**JOHN W. FISHER AND ASSOCIATES, INC.**  
**ENGINEERING CONSULTANT**

**FHWA Bay Bridge Pile Connection Plate Welding Investigation**  
**By John W. Fisher, PhD, PE**

Figure 1 Pile 2 plate F upper opening with runoff tabs removed and surface ground

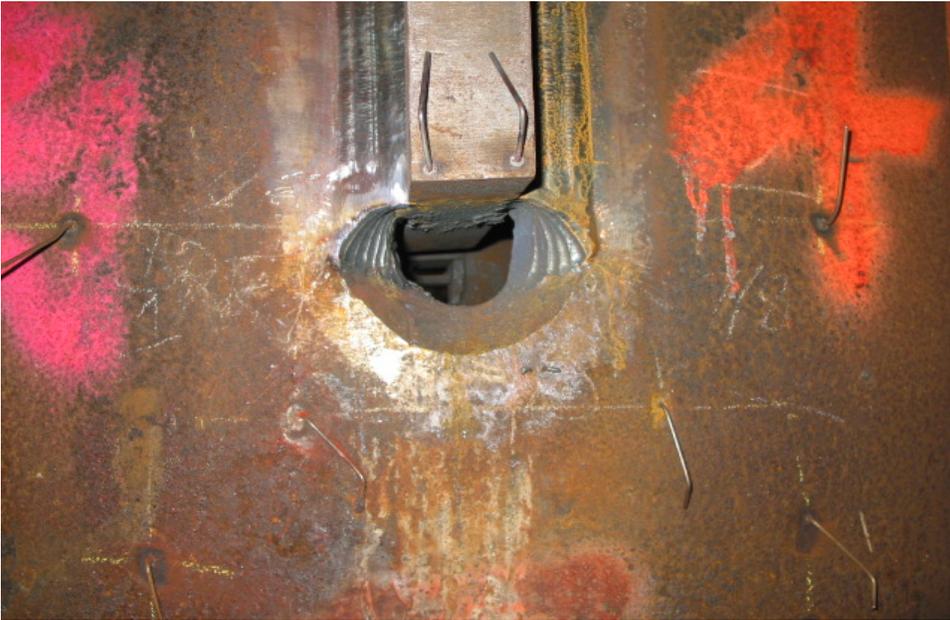
The site visit on April 18, 2005 provided an opportunity to examine a number of PJP welds in various stages of completion in Pier E4W. Characteristic of the conditions observed are provided in the photographs in Figures 1 to 8. Figure 1 shows a partially ground upper opening at Pile 2 plate F where the run off tabs have been removed, the area gouged and ground to shape.
